MIL-S-83731/22B
AMENDMENT 1
16 July 1997

SWITCH, TOGGLE, MINIATURE, LEVER-LOCK, FOUR POLE,
UNSEALED, LOGIC LOAD TO 5 AMPERES

This amendment forms a part of MIL-S-83731/22B, dated 29 March 1991, and is approved for use by all Departments and Agencies of the Department of Defense.

Figure 1 End View : Delete and substitute:

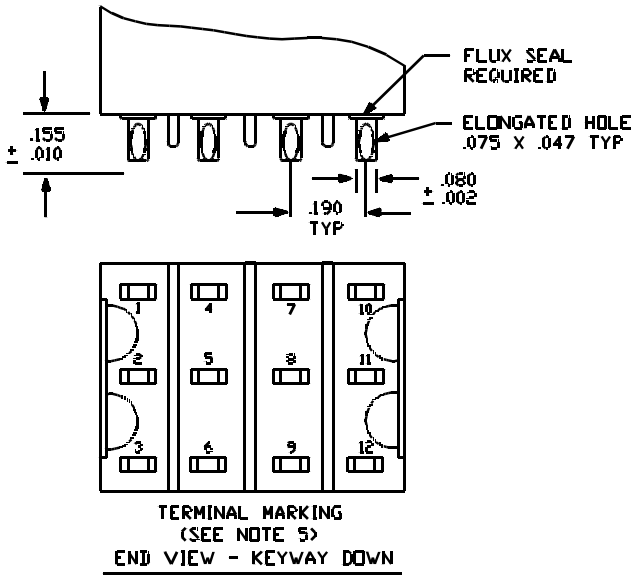
Figure 1 Top Right View, dimension ".185 TYP": Delete and substitute: ".185 ±.015"
